Based on Solder:Time, ClockIt, and Serial 7-Segment

TITLE: BigTime		SFE	SFE
Document Number:			REV: V15
Date: 9/9/2013 11:13:16 AM		Sheet: 1/1

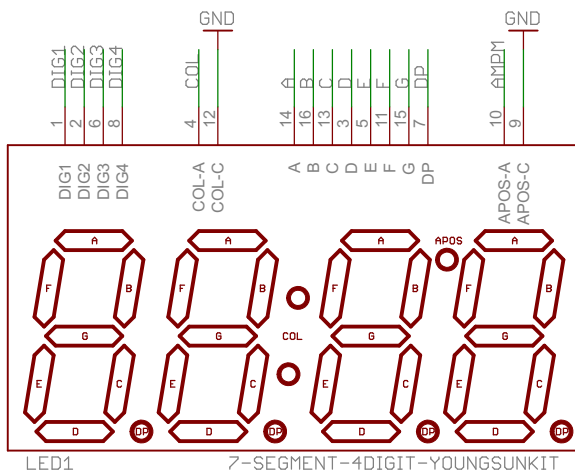
Changes to v11:
 Swap TX/RX
 Silk Update
 Tented the one via
 Increased R1 to 100k

Changes to v12 (1/6/12 MH/PL):
 updated package on 7-seg display
 updated package on ATMEGA328

Changes to v13 (4/26/12 PL):
 updated package on Coin Cell
 Added polygon pours around pads on coin cell connector to prevent pulling pads during assembly
 Moved SFE logo to avoid clipping

Changes to v14 (2/13/13 MAH):
 change coin cell to PTH

Changes to v15 (24 Apr 13 MAH):
 Scoot battery holder down a bit
